**DEPARTMENT OF TRANSPORTATION
STATE OF GEORGIA**

FILE CM-0000-00(617) Cherokee County **OFFICE** Preconstruction
P.I. No. 0000617
CWH **DATE** April 2, 2001
FROM C. Wayne Hutto, Assistant Director of Preconstruction
TO SEE DISTRIBUTION

SUBJECT PROJECT CONCEPT REPORT APPROVAL

SUBJECT PROJECT CONCEPT REPORT

Main Street, Proposed Typical Section
THE CITY OF
CANTON, GEORGIA

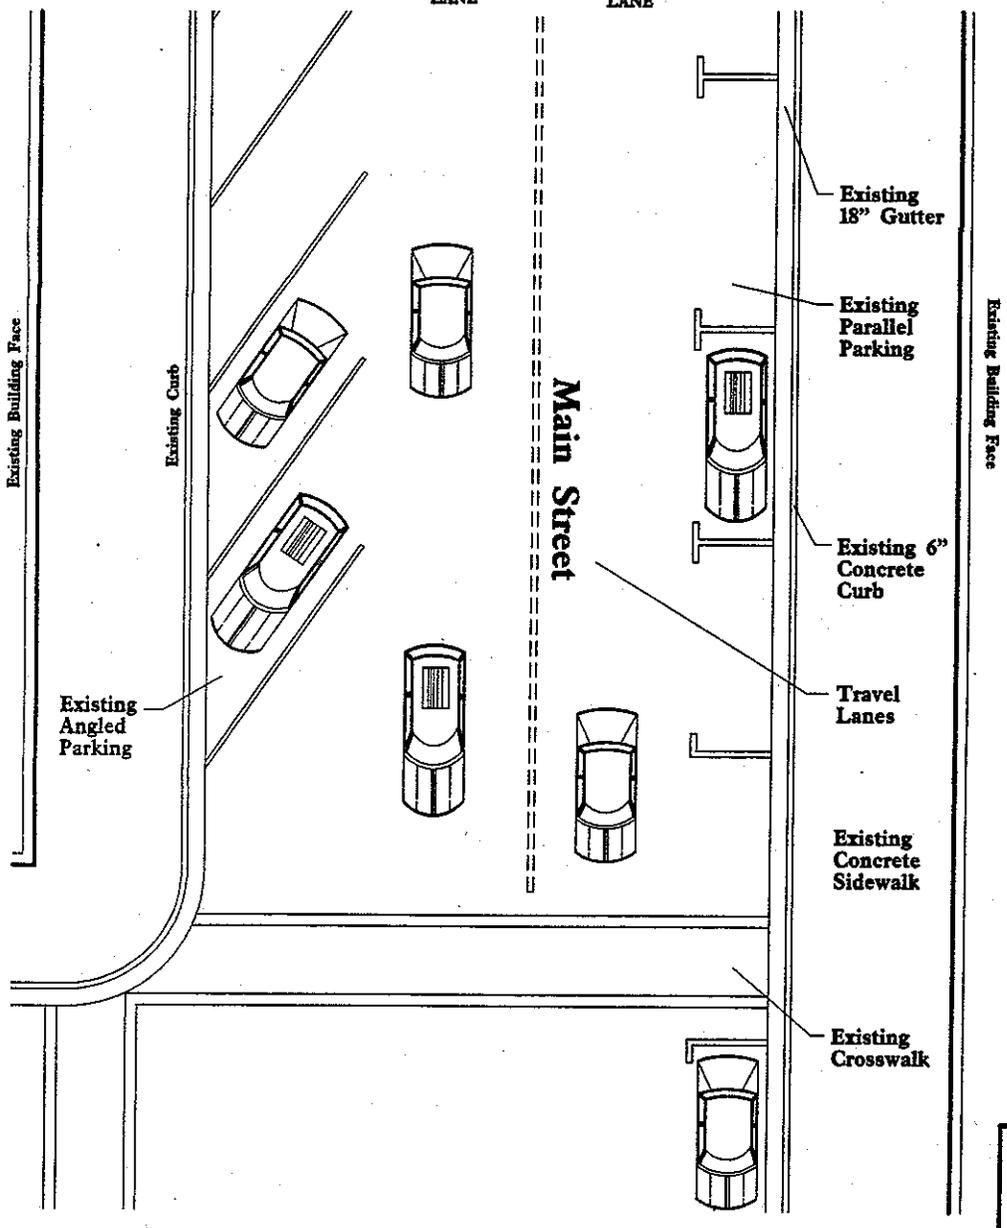
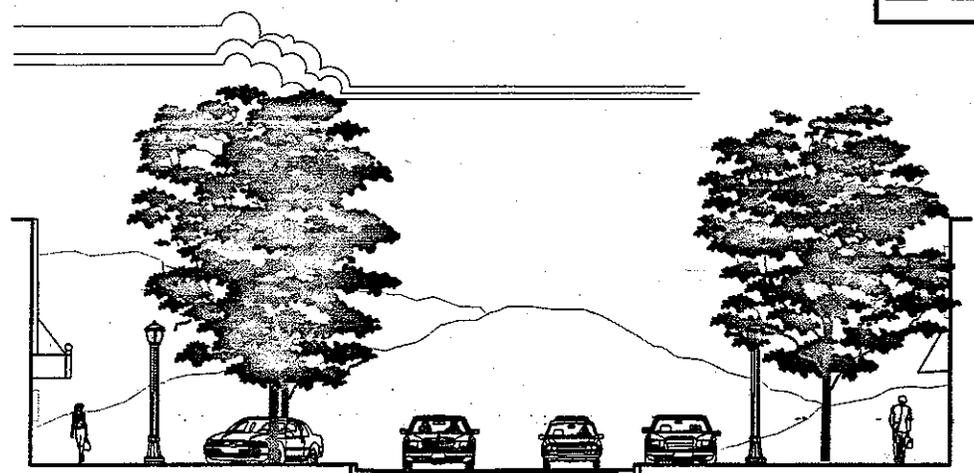
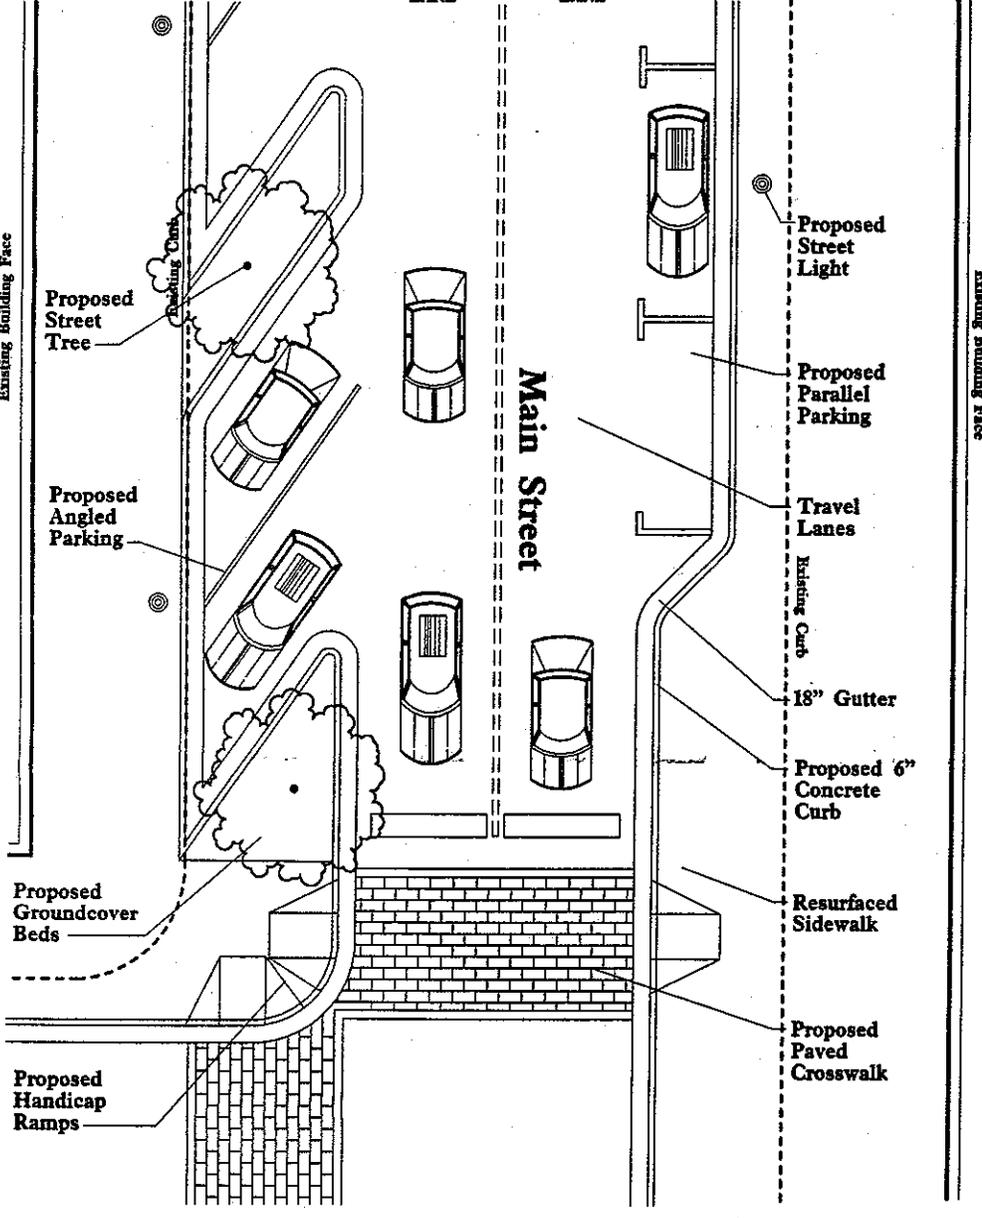
Though 12' lanes were originally requested, 11' lanes were discussed. The 12' lanes would take away from the sidewalks and parking. The 25 mph speed limit would allow for this width and aid in traffic calming. DeWayne Comer will look into accepting the 11' lanes and will contact Walt Ray with a final decision. Walt will not update the lane width to 11' until DeWayne has let him know about the decision.
